**Graythwaite Rehabilitation Centre  
Fourth Avenue, Denistone**

**Section 75W Modification**

**June 2012**

**Figure 2 - Northern Elevation (Approved)**

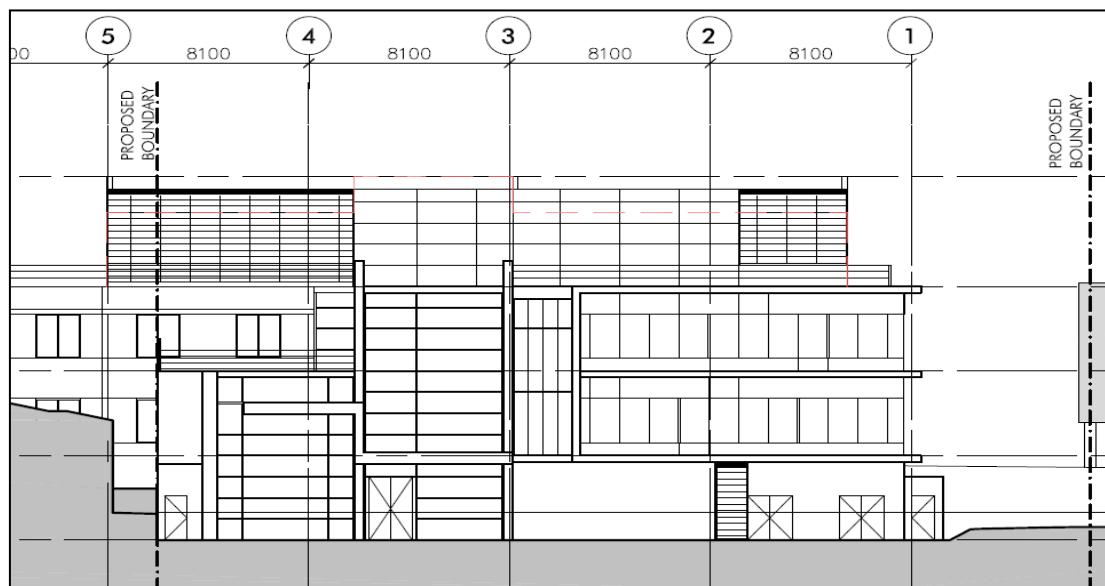
The proposal includes an increase in height of the northern and southern plant rooms located at Level 3 of the Centre from RL 105 to RL 106.7. This will result in an increase in height of these plant rooms by an additional 1.7 metres.

As discussed in **Section 6.2** above, the height of the main plant roof has been increased to RL 106.7 to match the approved height of the stair shaft and lift overrun.

- There are no height controls applicable to the site and the hospital campus includes buildings ranging in height of up to four (4) storeys in scale, at a height greater than RL 106.7.
- The proposed height of the plant at RL 106.7 has already been set as a precedent for the Centre by the approved height of the stair shaft and lift overrun.
- As can be seen in the figures below, the proposed changes to the approved plant will not result in any material change in the Centre when viewed from Fourth Avenue / the north.

**Figure 4 - Sections (outlined of approved plant illustrated by red line)**

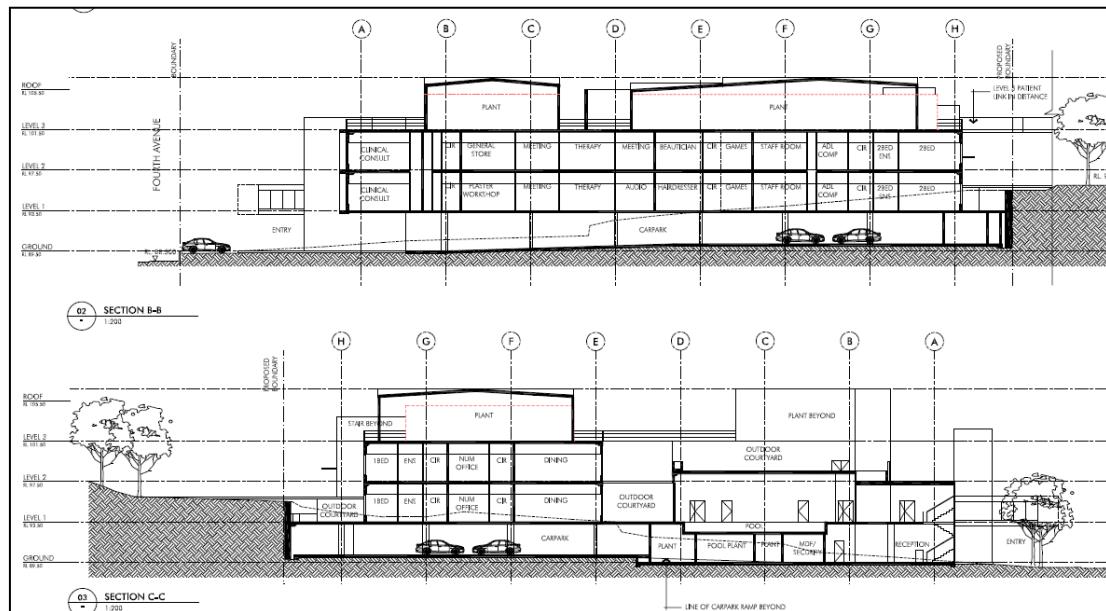
- The eaves gutter line to the plant is some 600mm below the plant ridge line at RL 106.1 due to the fall in the roof. The visual bulk and scale of the enlarged plant is minimised in this respect. Refer to **Figure 4** below.

- Where possible, the parapet has been stepped down to further reduce the visual bulk and scale of the enlarged plant (refer to west and east elevations at **Appendix 1**).
- The enlarged plant will not result in any significant increase in the "appearance" of a fourth level to the Centre with the plant maintaining the additional five (5) metre setback from the northern building line of level 2 below. The Centre will still maintain a part 3, part 4 storey appearance when viewed externally from the site.
- The portion of the plant that is proposed to be enlarged is setback from Fourth Avenue and maintains a smaller footprint than level 2 below and setbacks to all site boundaries.

**Figure 8 - Proposed Photomontage 2, changes circled in red**

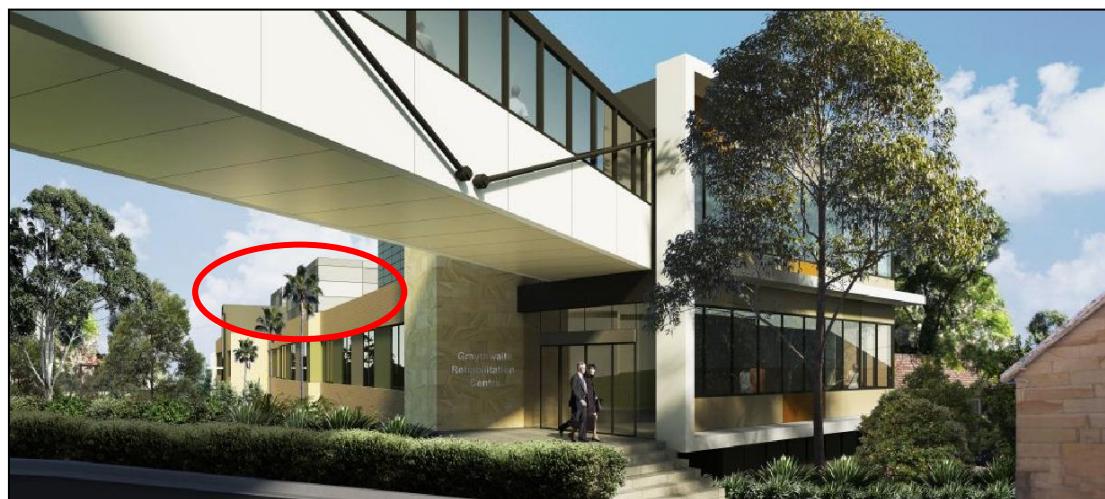
Further to the above, we refer to the photomontages prepared by Nettleton Tribe which clearly demonstrate that the visual impact of the proposed modifications is minor. The reduction in the size of the awning will result in a minor reduction in the "scale" of the Centre when viewed from Fourth Avenue. The enlarged plant will be partially screened by mature trees that will be implemented as a result of the landscape plan approved under MP 10\_0179 and the setback of the plant from "level 2" will aid in mitigating the potential visual impact of the enlarged plant, when viewed from street level.

**Figure 11 - Southern Elevation**

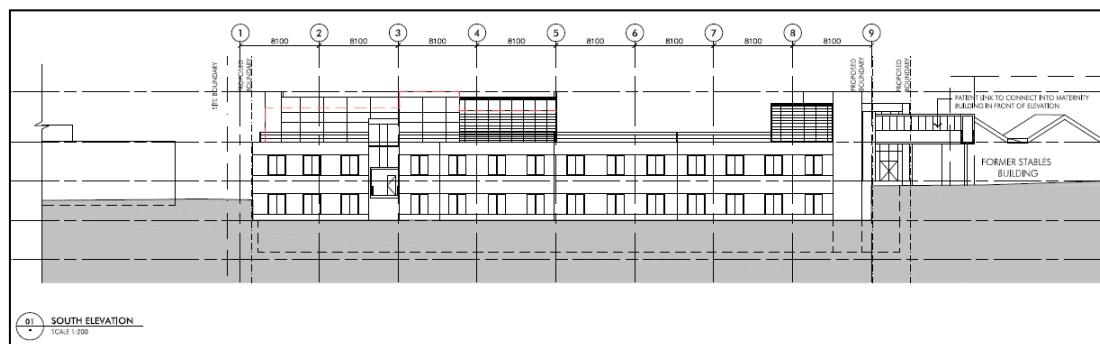
The approved Centre will be constructed to the west of the Stables and to the north-west of Denistone House. As the Stables building is the item in closest proximity to the Centre, we refer to the following figure which depicts the relationship between the Stables and the Centre.

- The heritage impact assessment undertaken by Graham Brooks and Associates for the original application did not raise any objection to the Graythwaite Rehabilitation Centre in relation to Denistone House, due to its physical and visual separation from the Centre by a series of intervening buildings. As the overall height of the Centre will not be increased, and the siting and general bulk and scale of the Centre will remain largely unchanged, we consider that the physical and visual separation of the heritage item to the Centre will be maintained and therefore, do not anticipate that the heritage significance or setting of Denistone House will be adversely impacted upon.
